INCH-POUND
MIL-PRF-39001C
AMENDMENT 3
10 July 2001
SUPERSEDING
AMENDMENT 2
17 February 2000

CAPACITORS, FIXED, MICA DIELECTRIC, ESTABLISHED RELIABILITY AND NONESTABLISHED RELIABILITY, GENERAL SPECIFICATION FOR

This amendment forms a part of MIL-PRF-39001C, dated 28 August 1997, and is approved for use by all Departments and Agencies of the Department of Defense.

FIGURE 2 Capacitance value versus DF. "

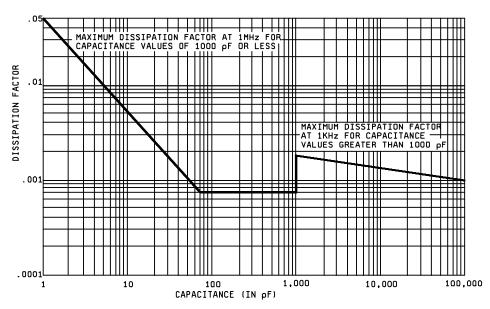
FIGURE 2, delete and substitute:
